# Product Discontinuation Notification

PDN26-24_SAM Rotary Partial Part numbers

This document is to announce the discontinuation of selected part numbers.
As part of this continuous improvement policy, in order to reduce the risk during life time of the product, we are introducing a new version of our SAM switches (power switches for seat adjustment) with dust protection: SAMXD series.

**Current version**

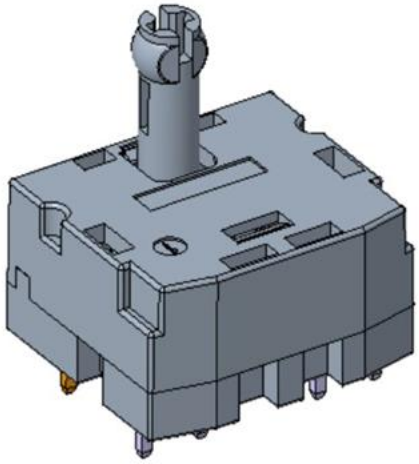
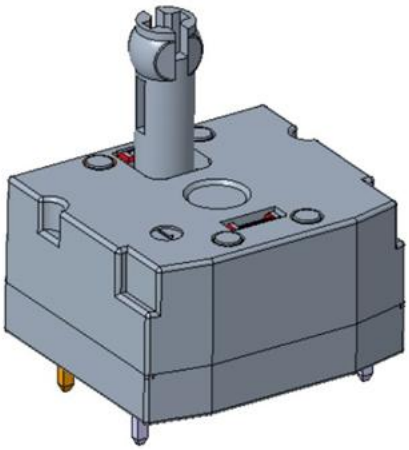
The existing SAM switches, by construction, are prompt to dust penetration. It needed a redesign to be able to overcome this weakness.
